M5 Junction 10 Improvements Scheme

Departures from Standard Report

TR010063 – APP 9.76

M5J10 Departure from Standards Report

Drawing Title
**DEPARTURE PLAN
DFS 15**

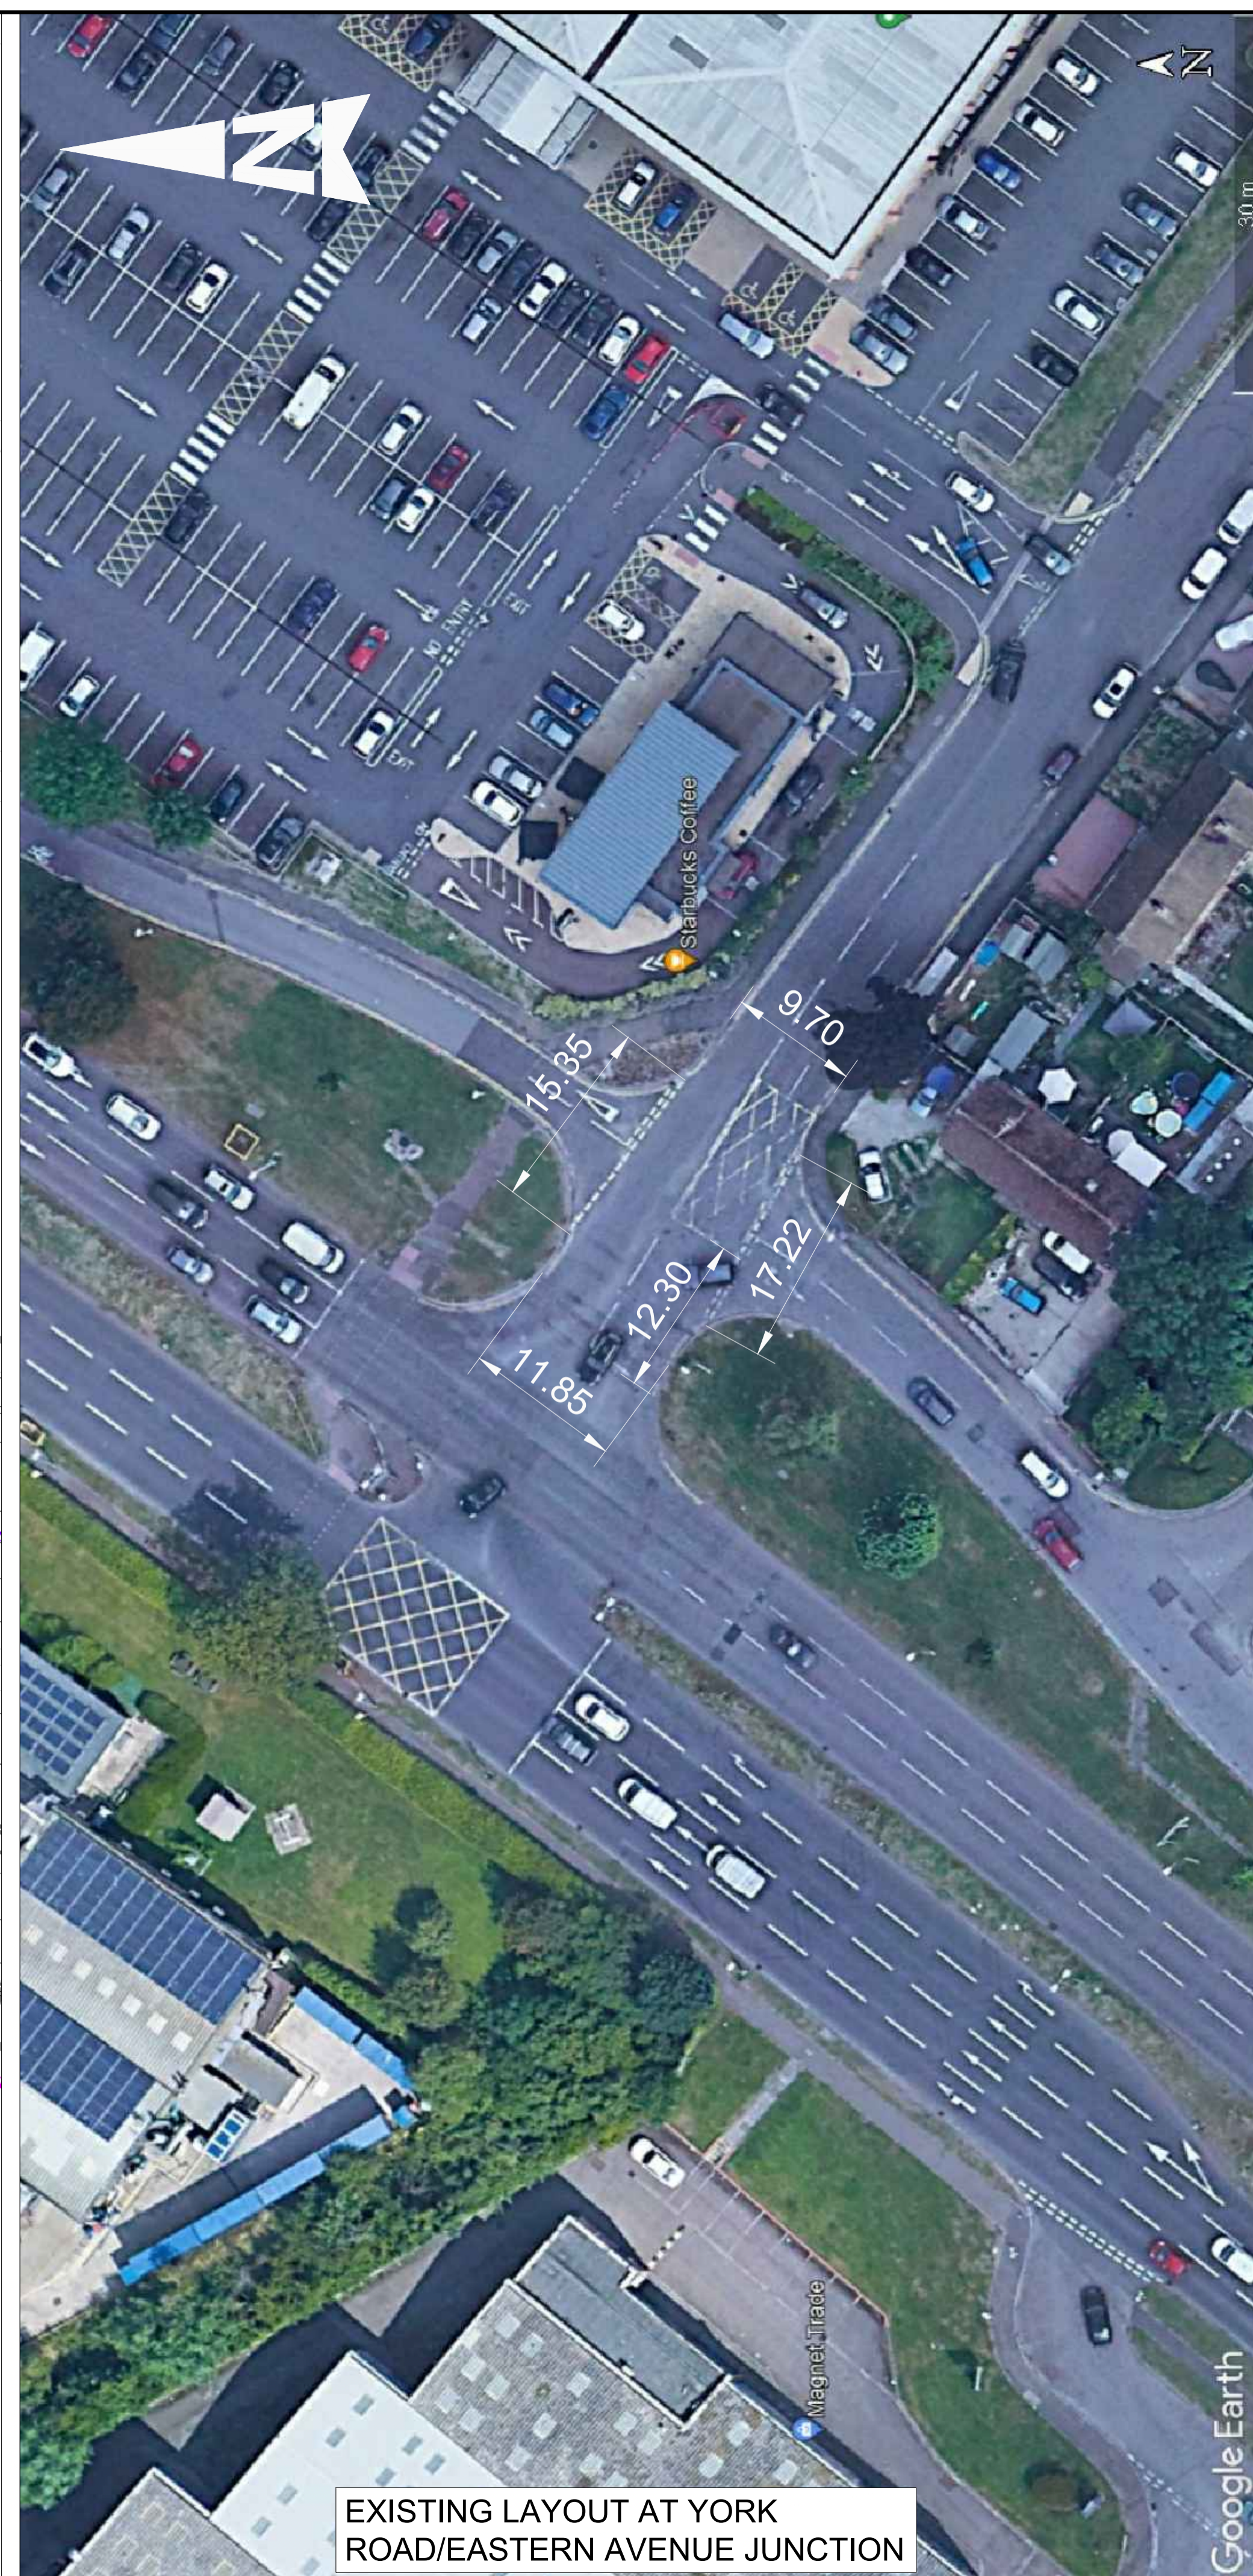
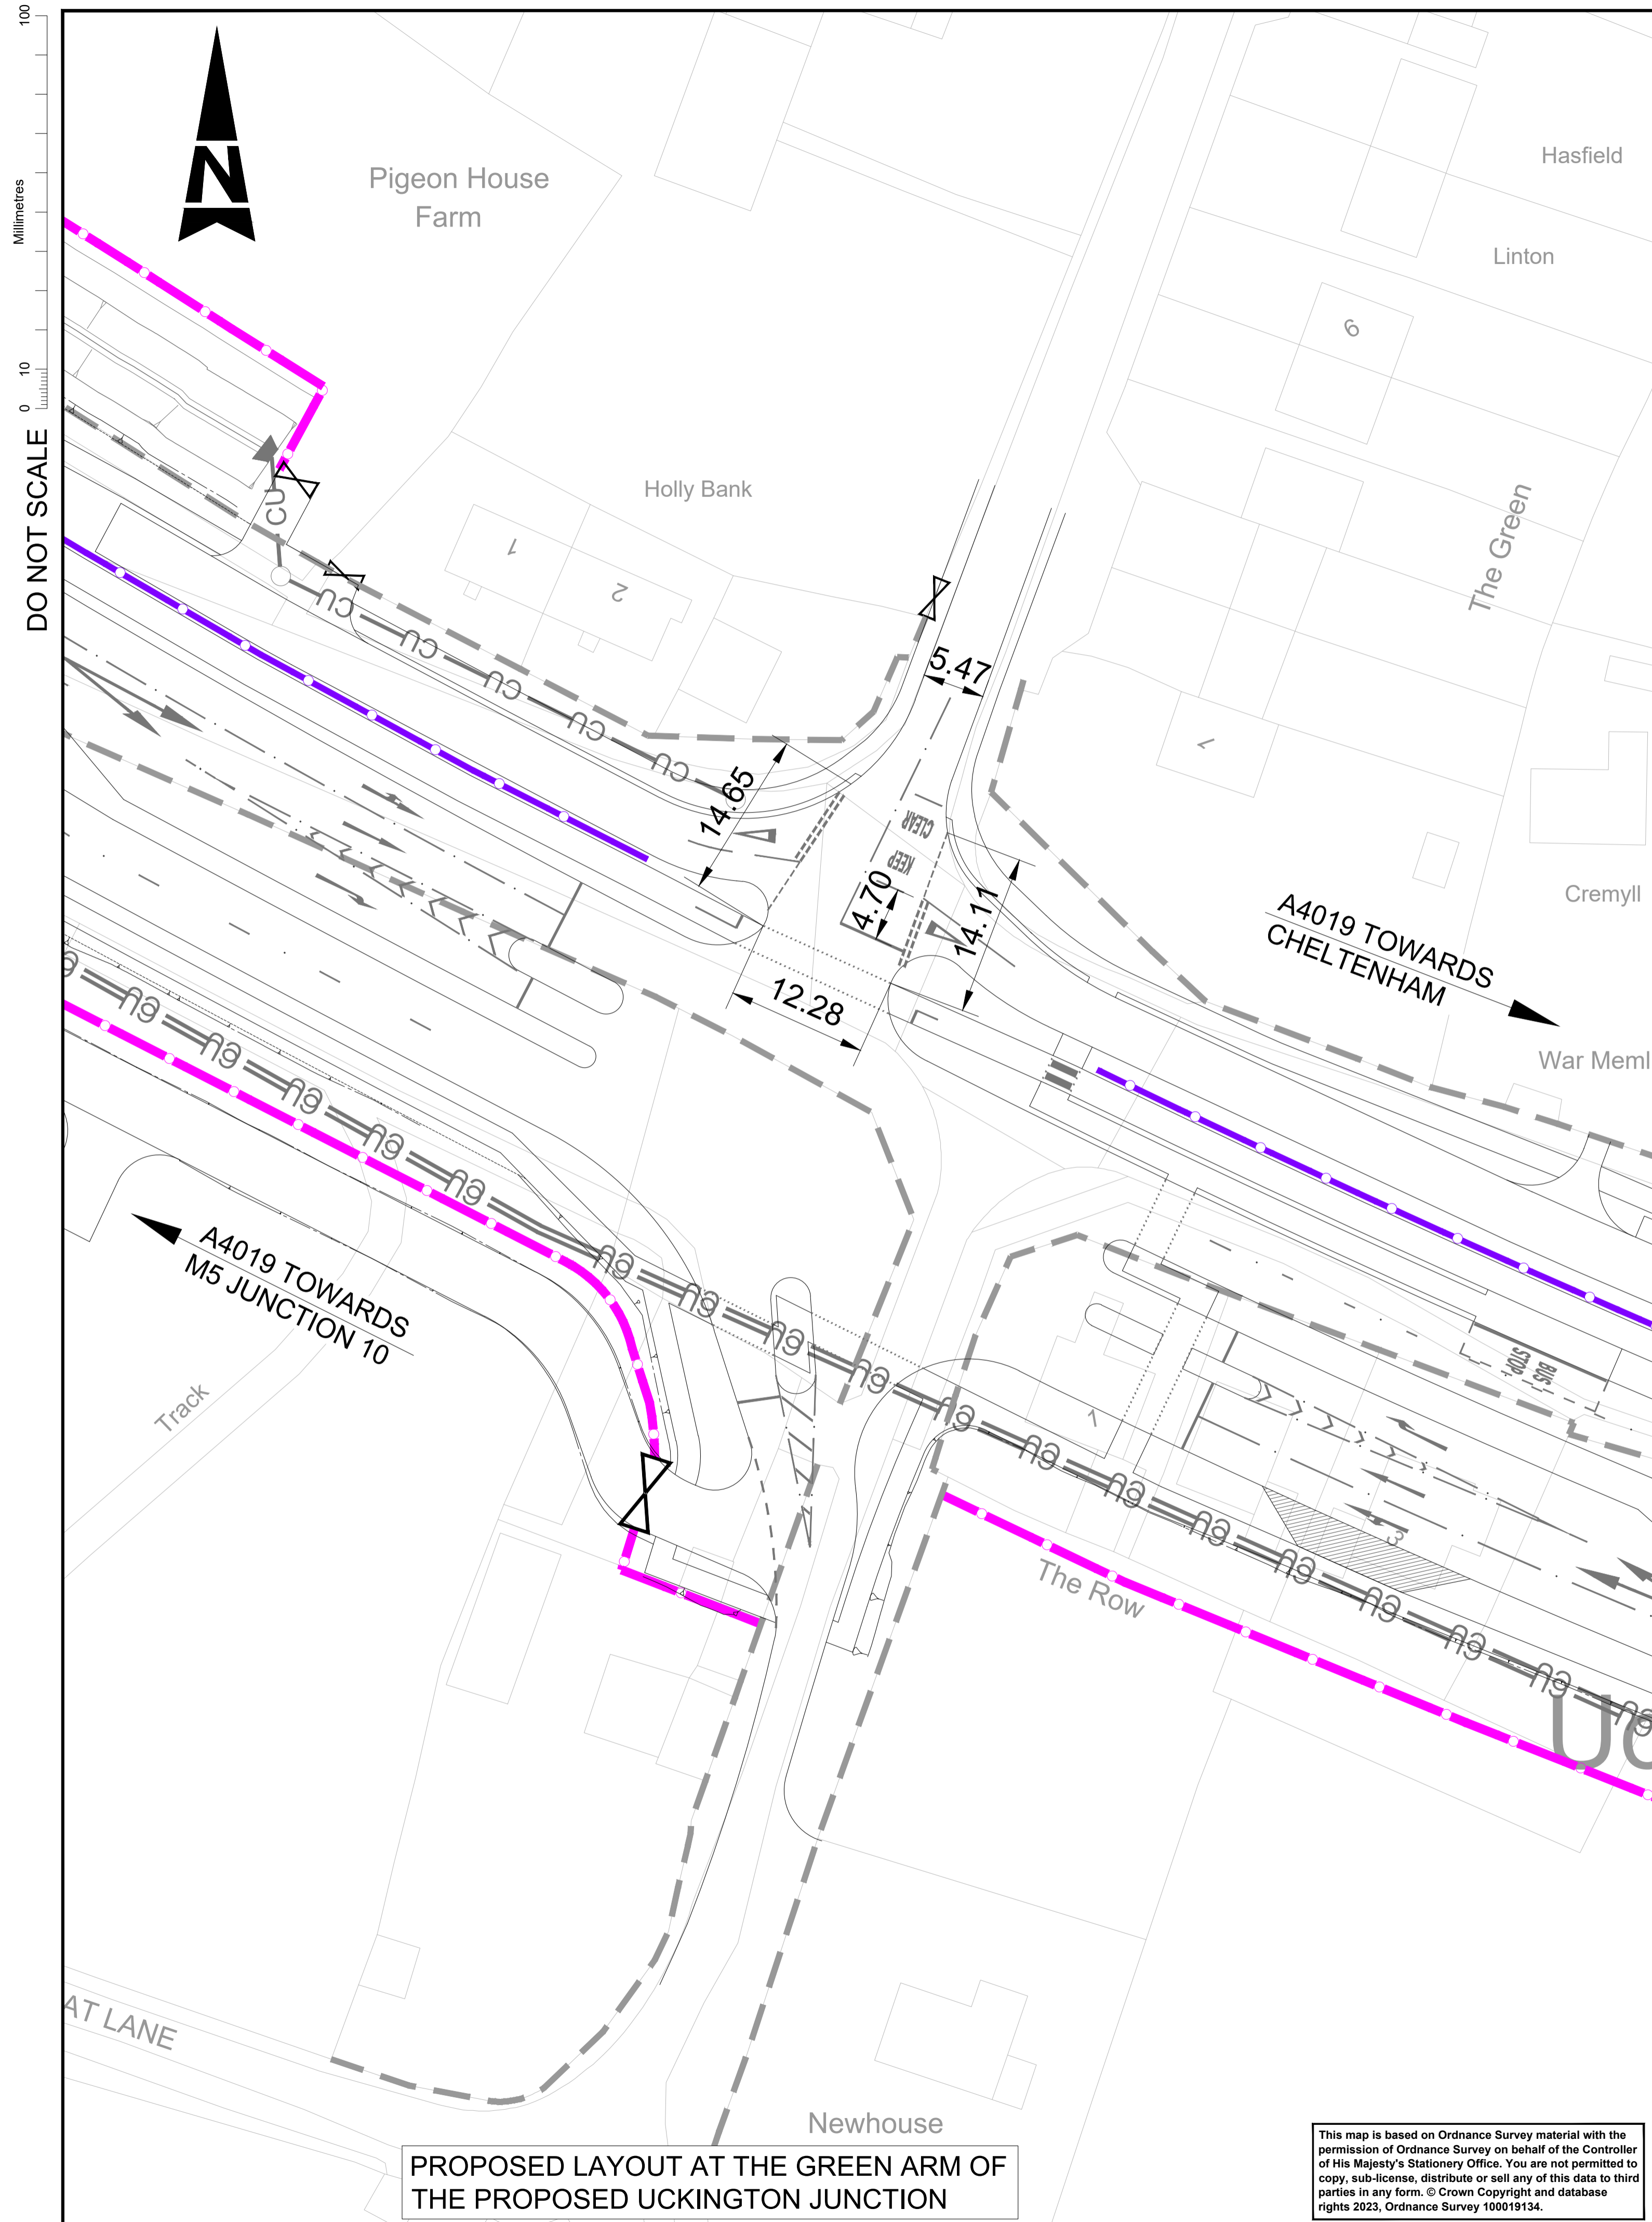
- 2.9.1. GCC Departures Review Panel questioned the justification for this proposed departure if only to reduce land take and further information was requested on a compliant design requirements. They also requested further information on the proposed separation between the access road and the A4019.

- 2.9.2. **POST MEETING NOTES:** A compliant design would involve increasing the proposed horizontal radii of the access road from 30m to 44m. This is shown on Drawing No. GCCM5J10-ATK-HGN-ZZ-SK-CH-000021 in Appendix A and would have a modest increase in land take requirements. The proposed radii are in close proximity to the junction and would assist in controlling speeds from vehicles entering and exiting the proposed Link Road.

- 2.9.4. If it is decided that the compliant design should be implemented, this change would fit within the current scheme red line boundary.
- 2.9.5. The proposed separation between the access road and the A4019 is 2.5m min. Figure 1-2 below shows an extract of the General Arrangement drawing at this location.
